RFQ NUMBER
 7011EC14

NINE CUBIC YARD 304 STAINLESS STEEL
DEMOUNTABLE ABRASIVE AND CHEMICAL SPREADER (HYDRAULIC)

ADDENDUM #4
7011EC14

5 CUBIC YARD STAINLESS STEEL
DEMOUNTABLE ABRASIVE AND CHEMICAL SPREADER (HYDRAULIC)

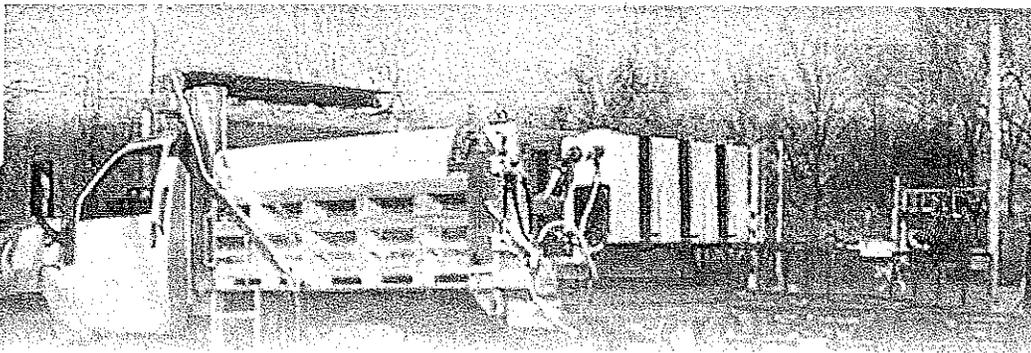
9. Is a 6.3 cubic yard capacity acceptable for RFQ14?
RESPONSE: No
11. The lighting drawing shows lights combined in housings but previous spreaders have been supplied with individual weatherproof housing as per the picture below. Are the individual weatherproof housings still allowed?

RESPONSE: As long as you still are in compliance with the spec.
